## Addendum 2

Issued May 3, 2024

RE: REQUEST FOR TENDER #2024-161-P01953  
Parkdale Elementary School – Gym & Main Entrance Renovation Project

Image #1

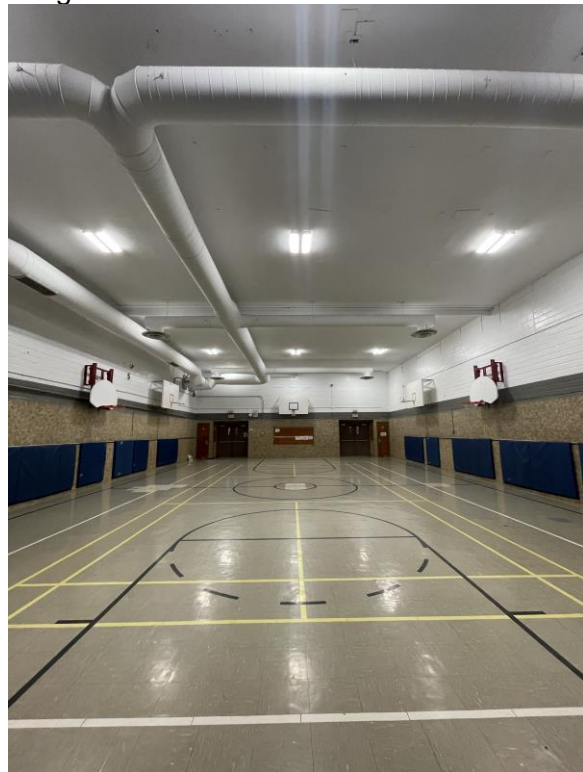
- 2) **Question:** Please provide proper details on the requirements for the gym ceiling. Is this a flat ceiling, or bulkhead? Is framing existing? Please provide details and a section?

**Answer:** Refer to the attached images #1 and #2. There are no existing drawings.

SHEET NO. A103  
DRAWN BY SK  
CHECKED BY RN  
PROJECT NO. 2320768  
SCALE AS NOTED

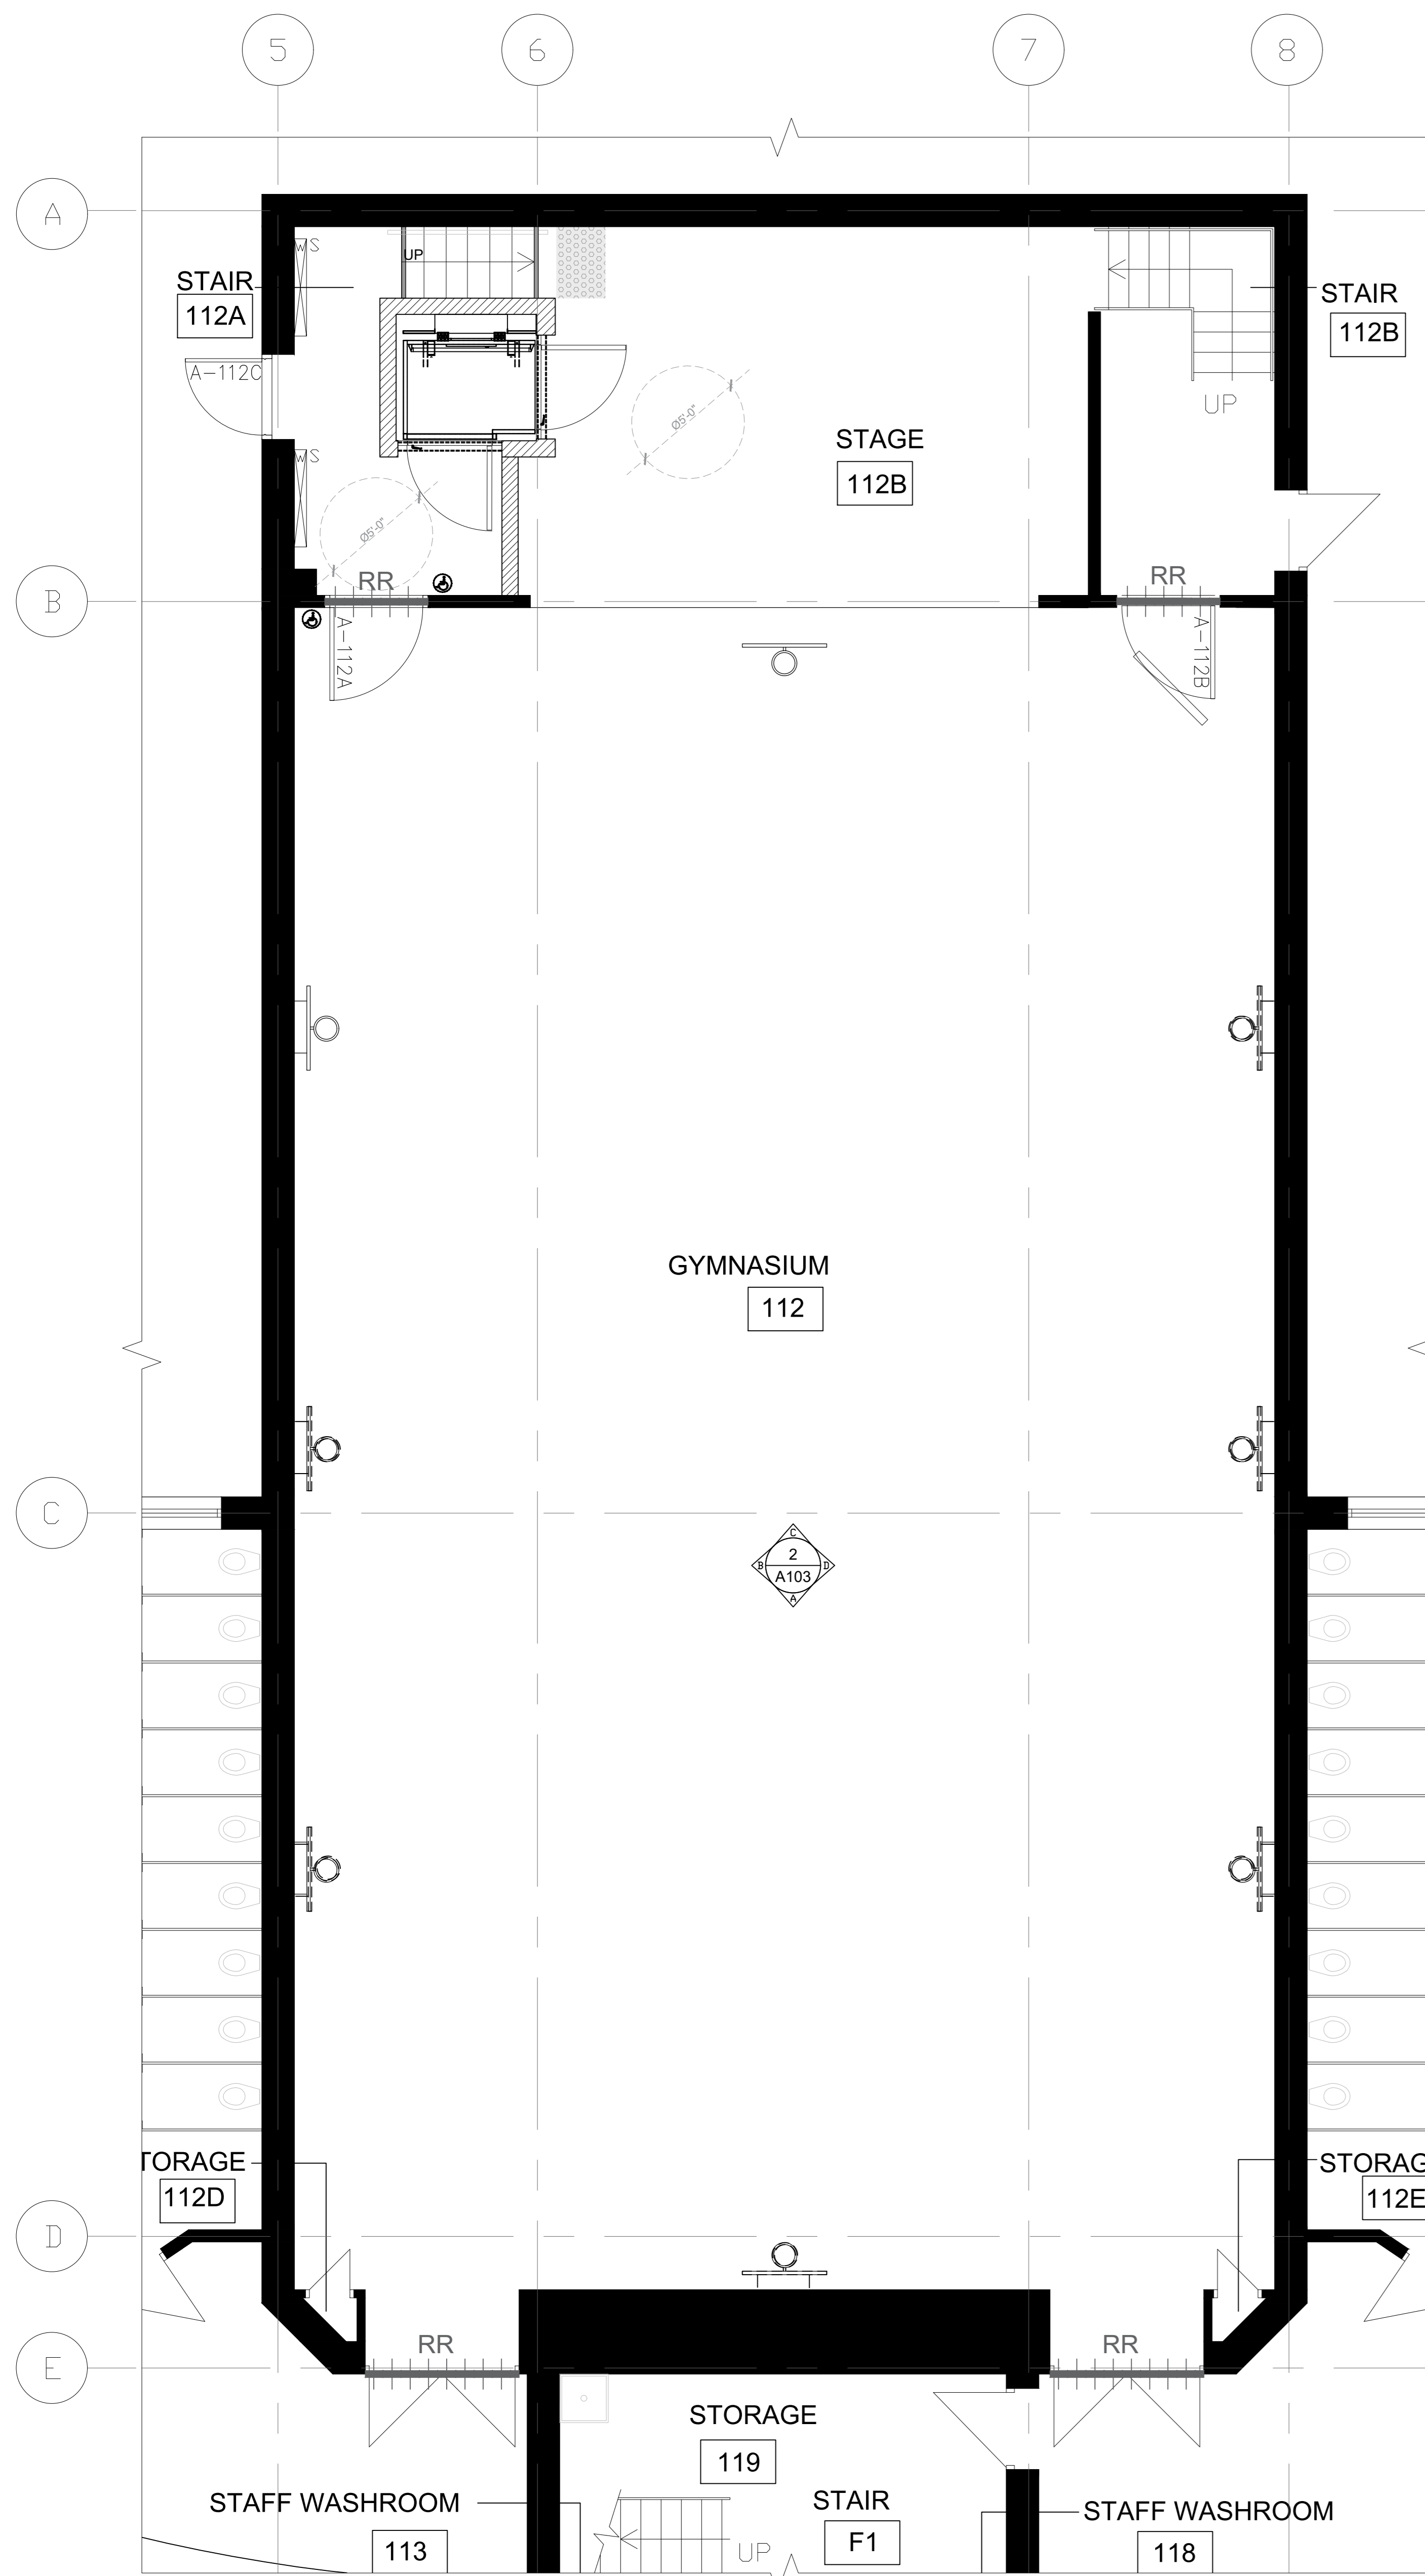
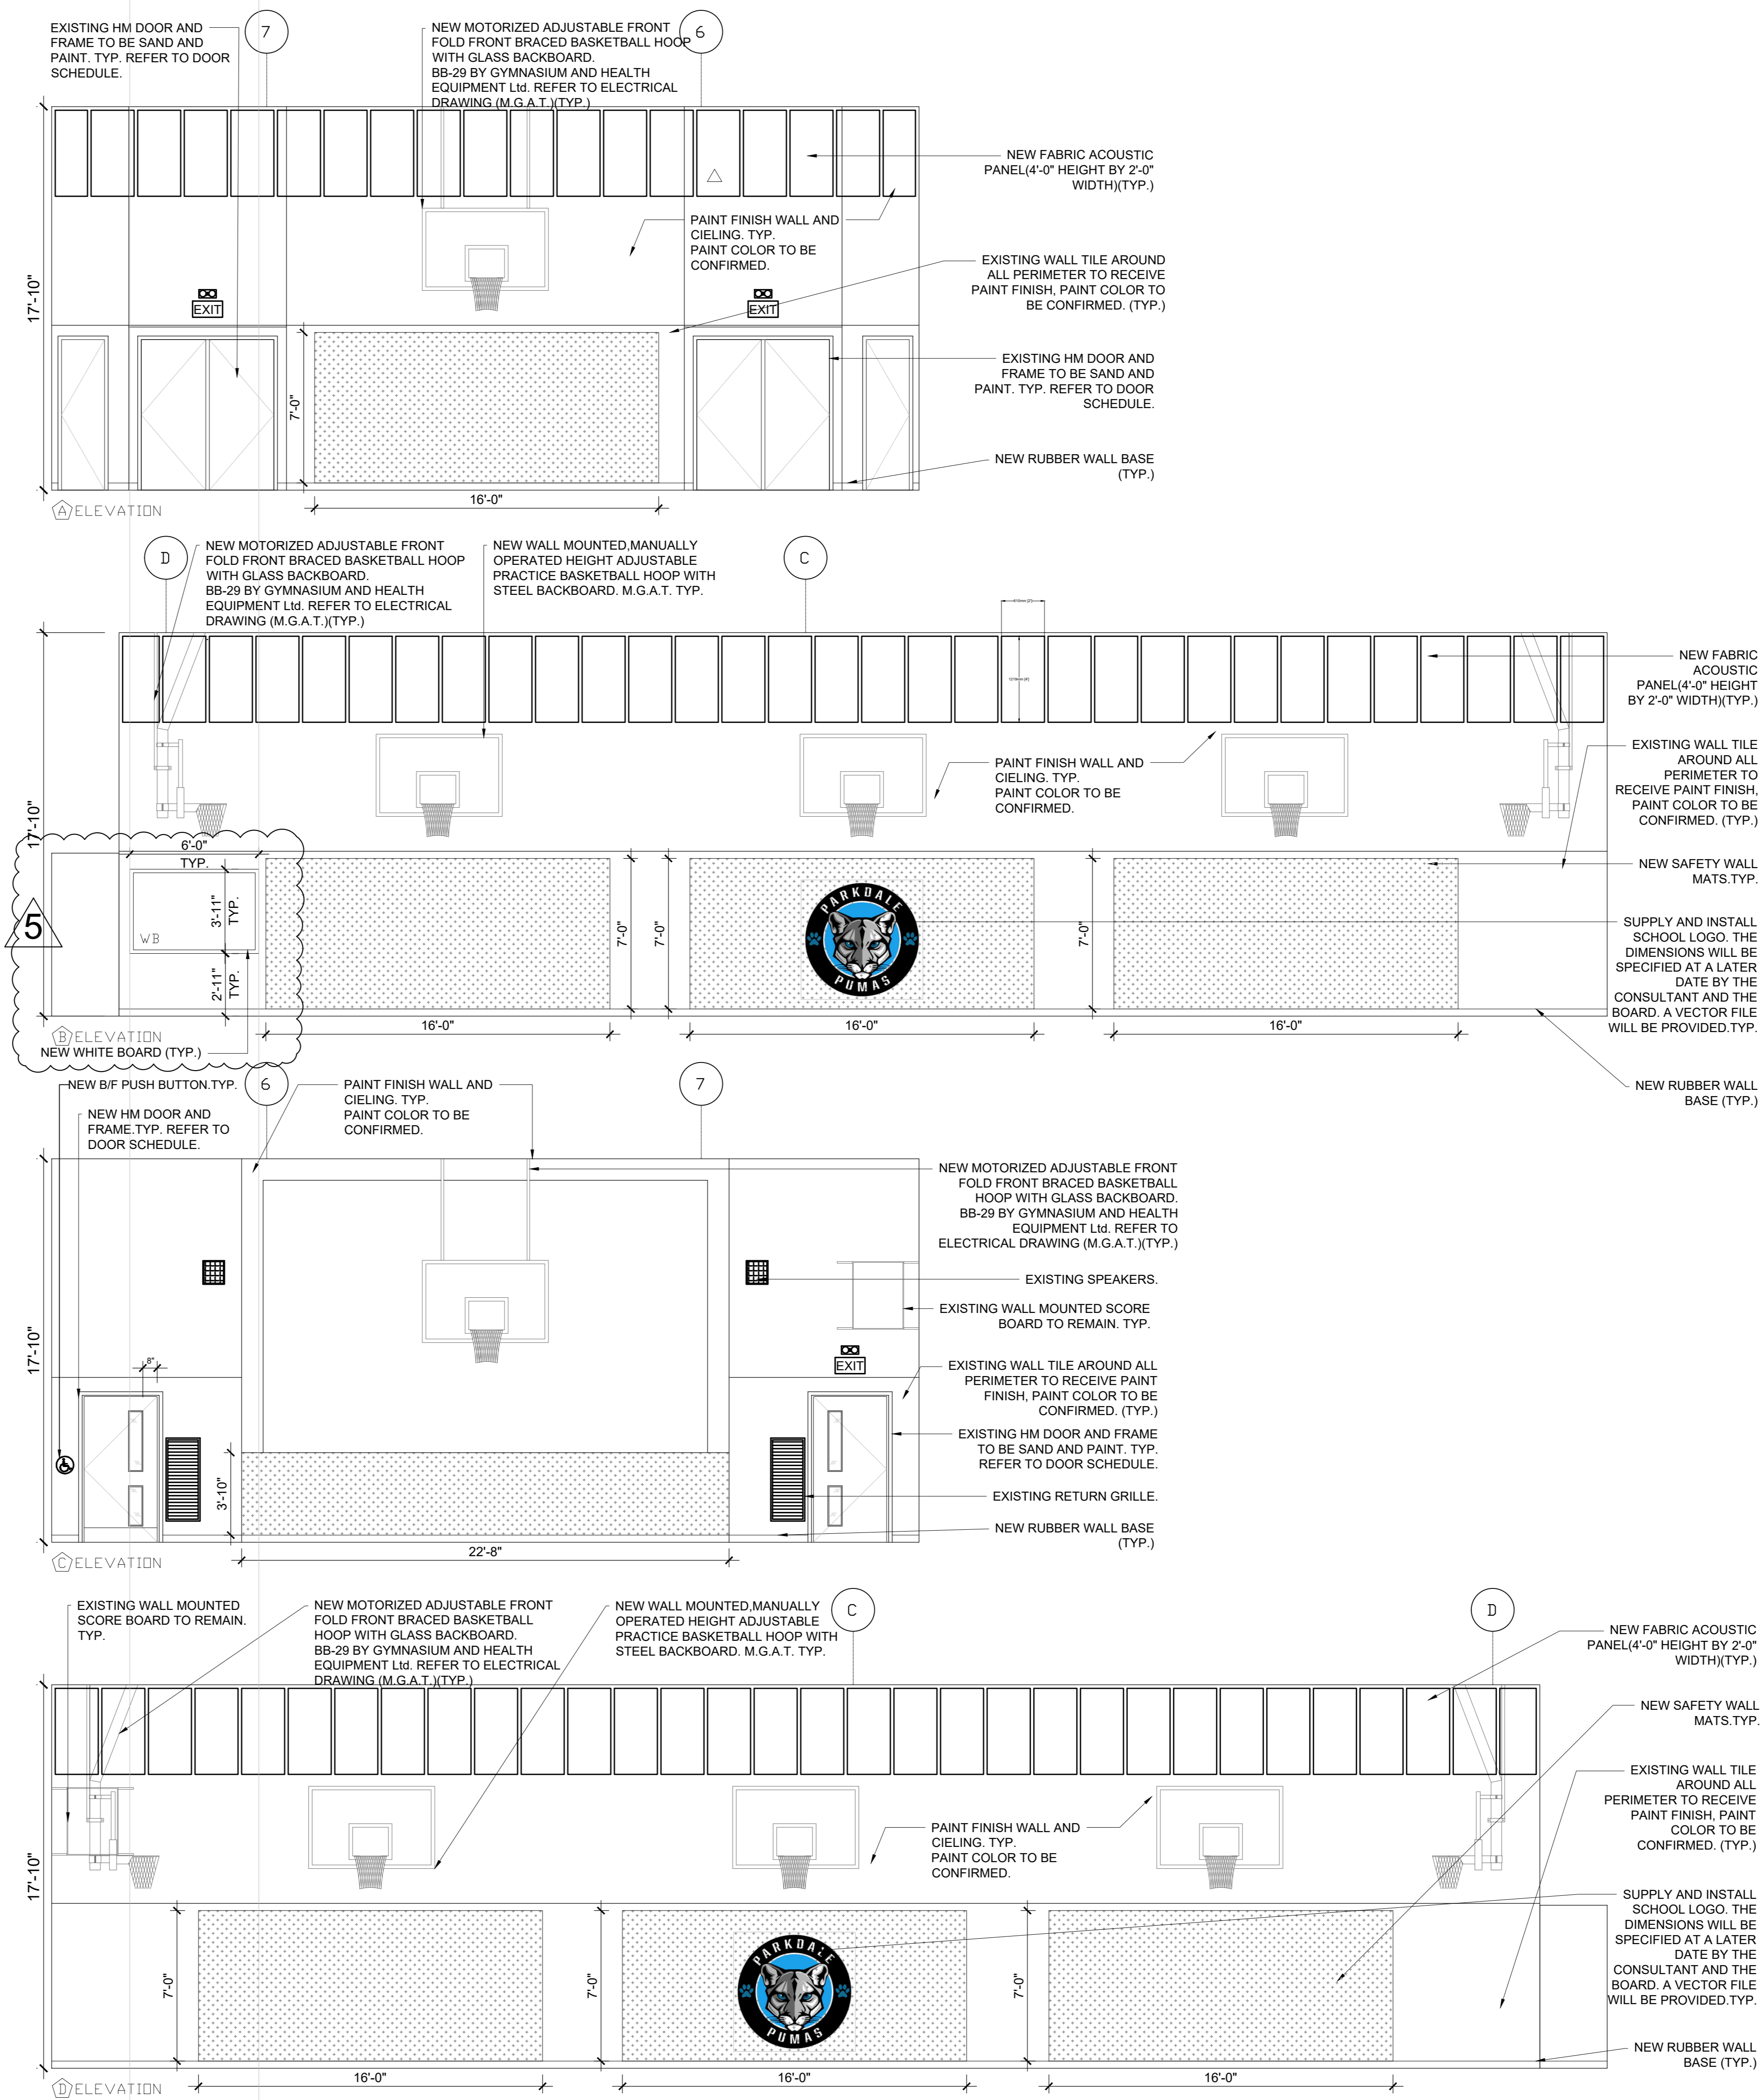
- 5) **Question:** Specifications included section 10 11 13, however these items do not appear to be shown on the drawings. Please clarify if these are required.

**Answer:** Refer to the attached architectural drawings A103, dated April 30, 2024, regarding the new whiteboard placement and measurements.
